AMENDMENTS STAGE 2
TITLE UNITS
BLOCK 18 SECTION 2 HUME ACT
 BUILDERS: CONVINCES
 OWNERS: C.J. CONVINE A.C. CONVINNE J.W. CONVINNE
 CONTACTS: CHRIS CONVINNE 0417453000
 AND JOHN CONVINNE 0417678654
 DATE: 3/6/02
 NO PART OF THESE PLANS MAY BE COPIED
 ELECTRONICALLY OR MANUALLY WITHOUT THE WRITTEN PERMISSION
 OF THE OWNERS, C.J. CONVINNE A.C. CONVINNE J.W. CONVINNE

AMENDMENTS ONLY

AMENDMENTS STAGE 2
TITLE UNITS
BLOCK 18 SECTION 2 HUME ACT
SITE, LANDSCAPE AND TITLE UNITS PLANS
SITE AREA: 5781 sqm BUILDING: 2073 sqm
SCALE: 1:200 PLOT RATIO: 35%
DRAFTSMAN: J.W. CONVINNE DATE: 30/7/02
ENGINEER: JAN VAN DER VEEN
BUILDER: CONVINNES

SITE PLAN

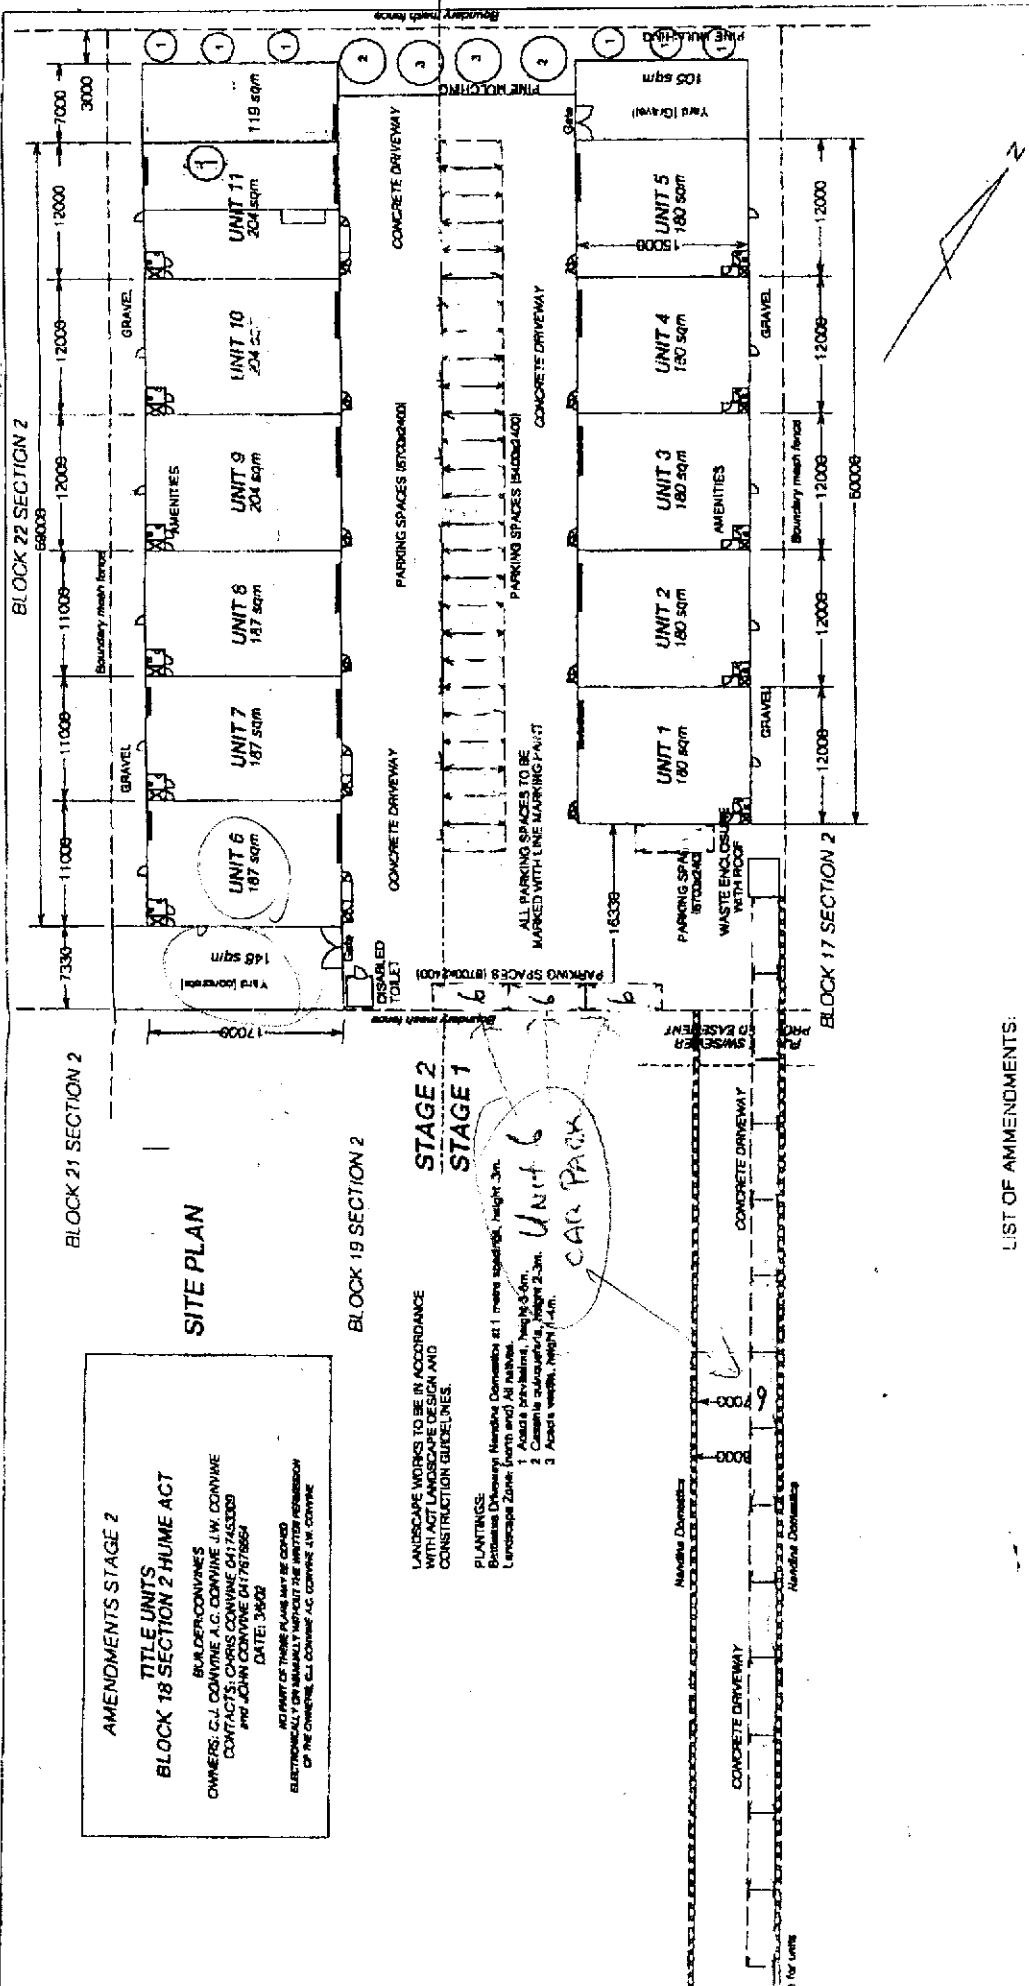
LIST OF AMMENDMENTS:
 1. Remove part colourbond Internal wall Unit 11.
